St. George Romanian orthodox church-update

PROJECT: Drainage Easement Modification

**CITY OF LAS VEGAS
INTER-OFFICE MEMORANDUM**

SUBJECT: Technical Drainage Study for:
**St. George Romanian Orthodox Church – Update
Drainage Easement Modification**

Cross Section for Triangular Channel - 1

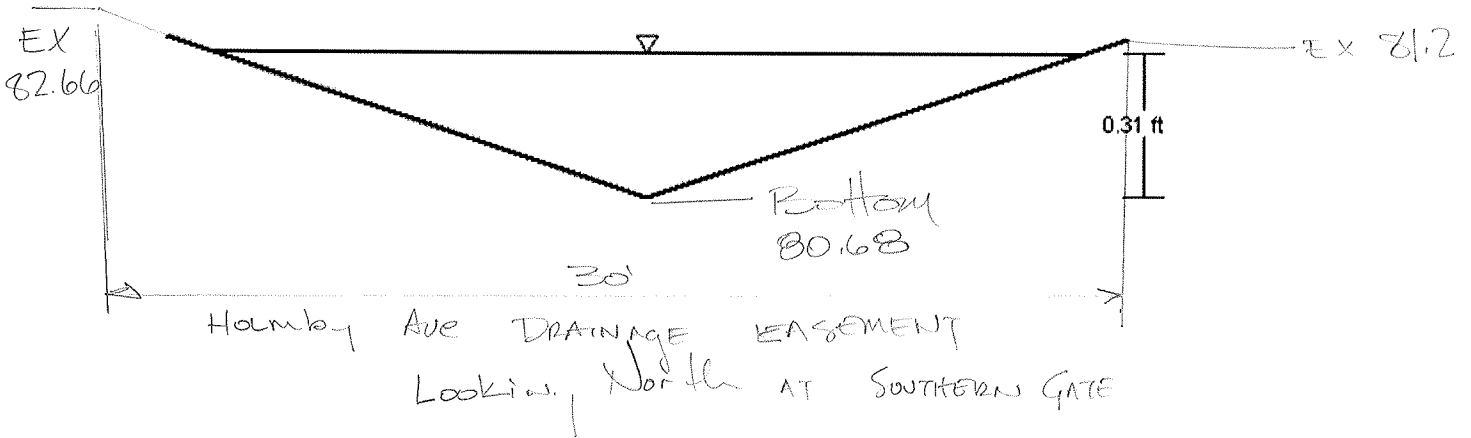
The profile of the drainage swale associated with the subject project needed to be regraded as a result of existing conditions on site. There is a very dense caliche layer just below the existing grade. We would therefore propose a change in the proposed grade of the swale. Attached are owner-provided topographic shots at each of the gates along the drainage easement. The shot on the north gate is lower (79.47 versus 80.07) than proposed, so there should not be an issue there. On the south gate, the grade shot there is 80.68 versus 80.20. Attached is a calculation which determined that the water remains inside the swale at a depth of flow of 0.31 feet. The total depth from the bottom (80.68) of the swale to the grade at the gate (81.2) is 0.52 feet. This does not meet swale free board requirements; however, it does provide 0.21' of freeboard, and the 8 cfs flow rate will not adversely impact adjacent or downstream property or facilities.

X	is approved subject to conformance to all City standards and the following conditions:
	must be resubmitted or supplemented including the following:
	is conditionally approved subject to Clark County Regional Flood Control District concurrence.
